AGENDA ITEM 24

PROPOSED CHANGE ORDER
No. 00074

TITLE: *Parking Lot #2 Repairs*

PROJECT: Williamson County Regional Park

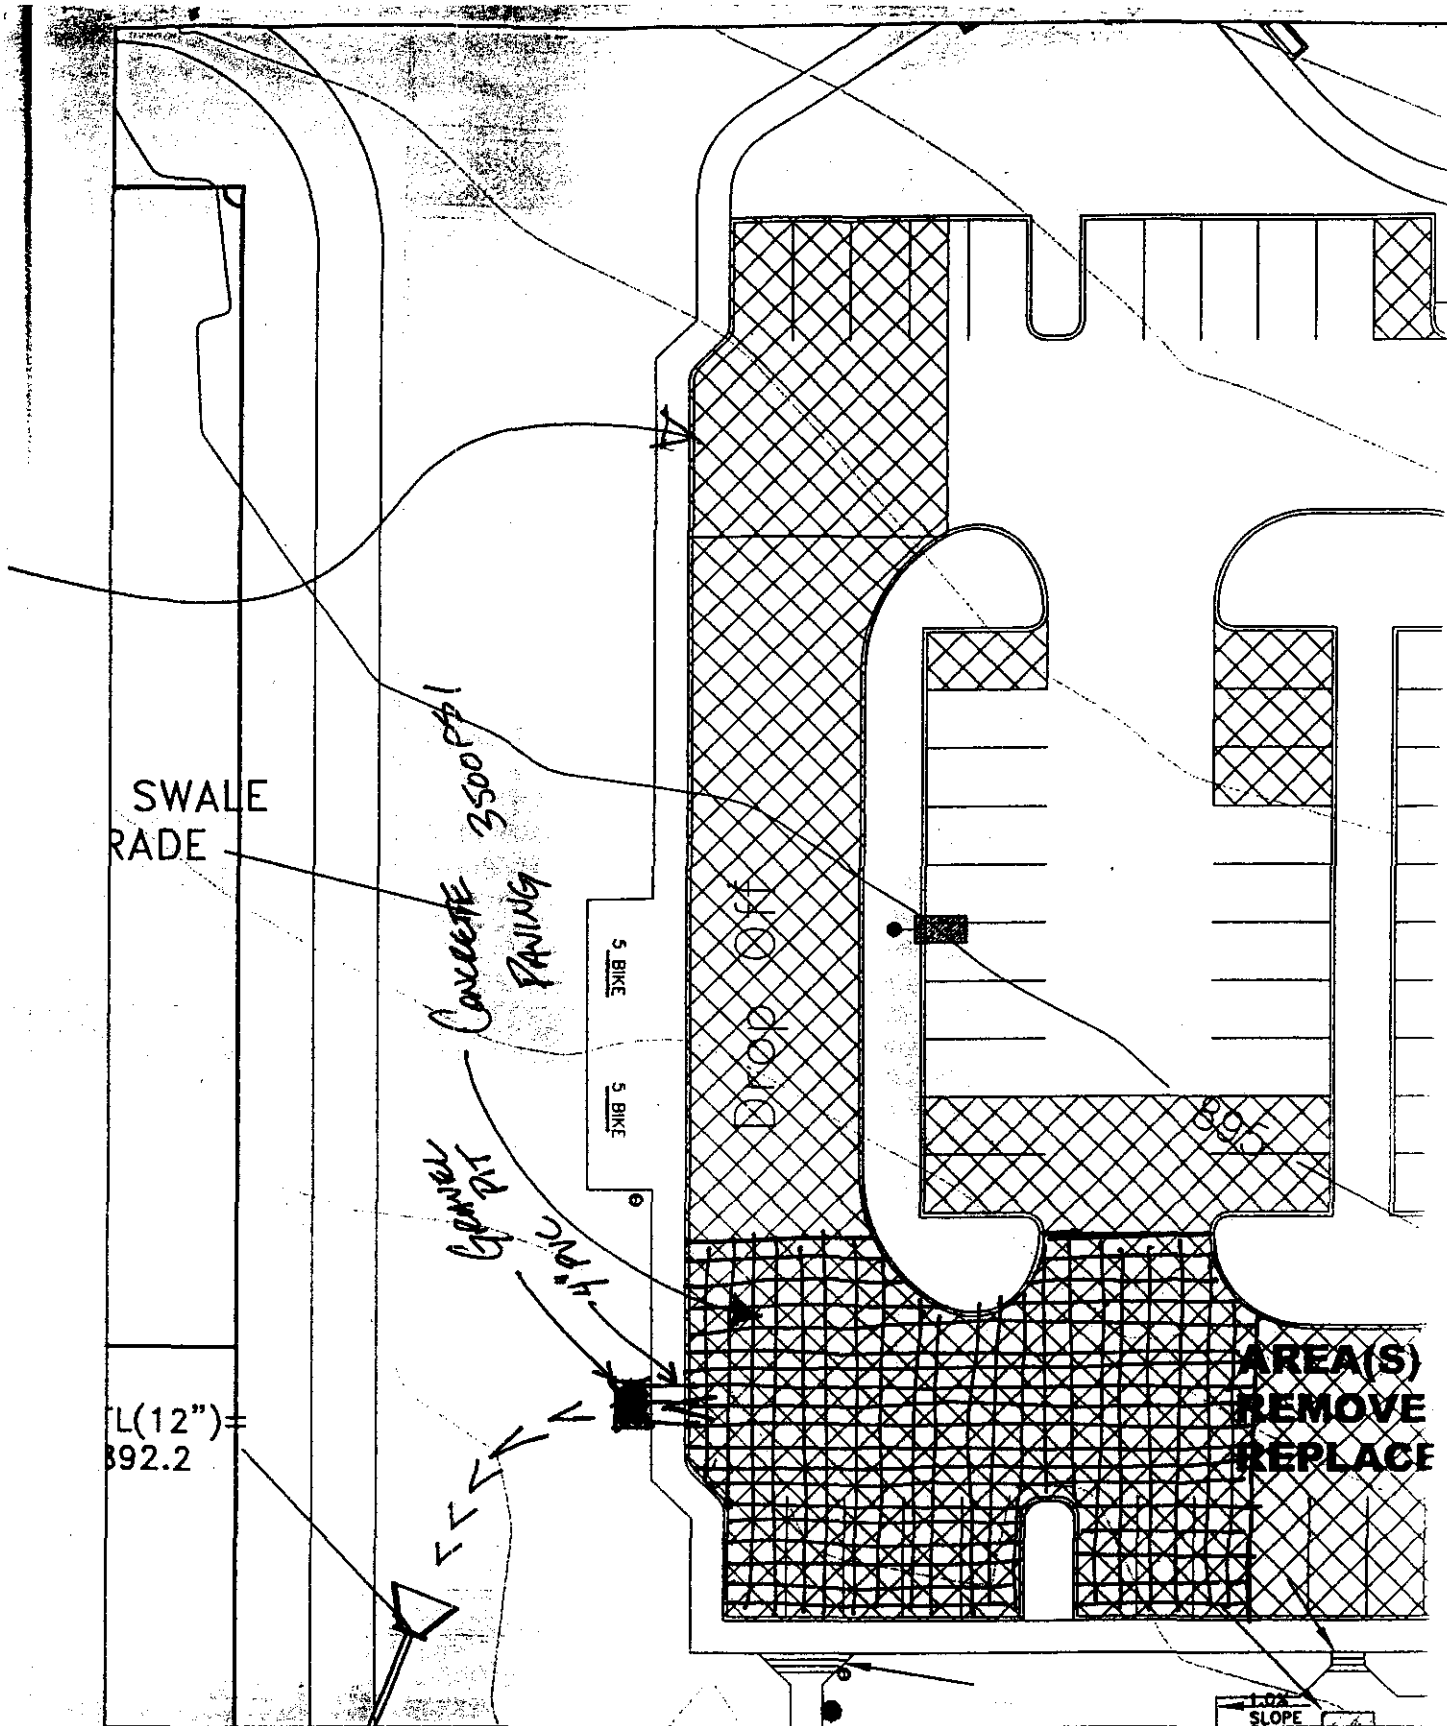
This change incorporates the additional work performed in Parking Lot #2 at the Williamson County Regional Park project. Sub-surface or groundwater was found to be in the general area of Parking Lot #2 after initial paving was constructed. This change includes the additional work to bridge this pre-existing condition. This change includes: all labor, material, equipment, supervision and incidentals to excavate the hotmix and flexible base in the failed areas, approximately 5400 square feet; install approximately 6" of 3/4"-1-1/2" washed river rock; #4 reinforcing bars on 16" O.C.E.W.; and 6" of concrete. Approximately 250 lineal feet of 4" perforated PVC pipe was installed on the north side of Parking Lot #2 to act as a french drain. Please see attached.

ALL OTHER AREAS TO BE RE-PAVED WITH HOT MIX (TYP)

Item	Description	Quantity	Units	Unit Price	Subtotal	Fee %	Fee	Net Amount
00001	French Drain @ North side of Parking area	1.000	ls	\$2,200.00	\$2,200.00	0.00	\$0.00	\$2,200.00
00002	Remove flexible base to subgrade	5400.000	sqft	\$1.00	\$5,400.00	0.00	\$0.00	\$5,400.00
00003	3/4"-1-1/2" washed river rock	70.000	cuyd	\$15.00	\$1,050.00	0.00	\$0.00	\$1,050.00
00004	Concrete Paving with steel reinforcing	5400.000	sqft	\$2.75	\$14,850.00	0.00	\$0.00	\$14,850.00
